Meeting Name: Town Council Meeting
Meeting Date: January 22, 2025
Prepared By: Stephen Mayer
Item Title: Application for a Major Development and Site Plan Amendment to the 700 Ocean Drive Planned Unit Development

The Town received an application for a Major Development and Site Plan Amendment from the “700 Ocean Drive Homeowners’ Association” (“Applicant”) for properties located at 714 and 716 Ocean Drive (“Properties”). Leslie Thomas of E.T./Thomas Construction, Inc. (“Agent”) is the agent representing the Applicant/Owners.

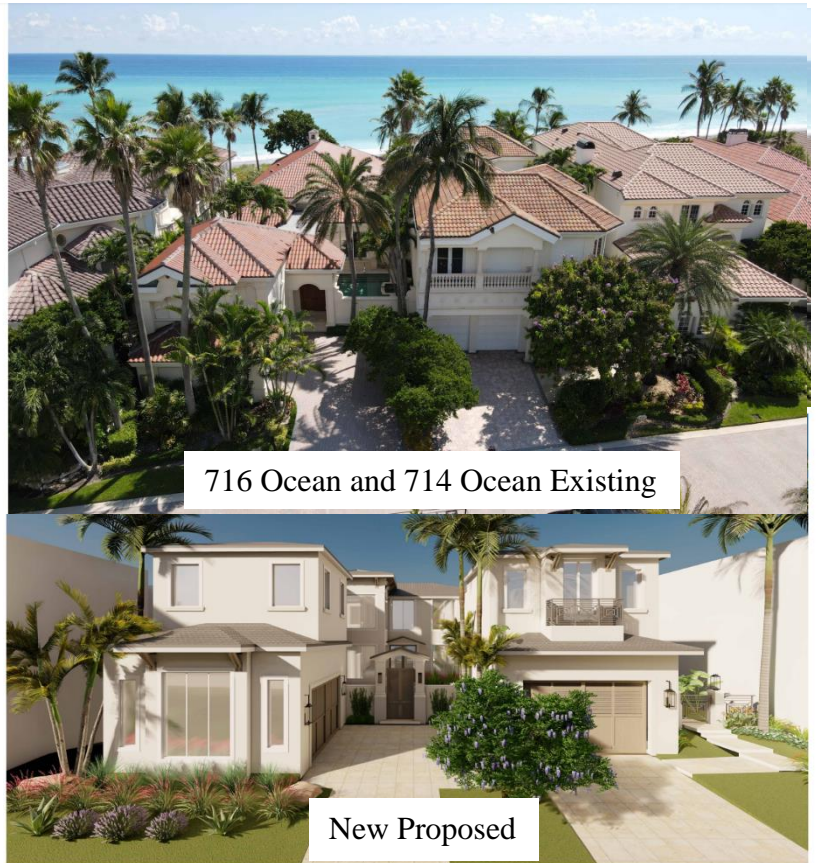
The elevations consist of some Florida Vernacular design elements such as the large lantern lights, large patio spaces, balconies, lush landscaping, and louvered/paneled garage doors just as 704 Ocean Drive did to update the home around 2017. The rear will feature an abundance of glass to capture the ocean view and feeling of outdoor living. Please see picture to the right of 704 Ocean Drive, as the inspiration for the new home.

Applicant's response: Harmony: The proposed home to replace 714 & 716 Ocean Drive will relate directly to the other 8 homes in the 700 Ocean Drive subdivision. All homes maintain a 20' front setback with a 10' side setback. The existing building elevation from sea level will remain the same, exceeding the requirements of FEMA + 10" by about 10 feet. We will keep the properties, garages, and main finish floor level at the same height as the existing homes. This will also allow us to maintain the max height of the structure to relate to the other 8 homes in the community, not just in design, but also in how they are perceived from the street.
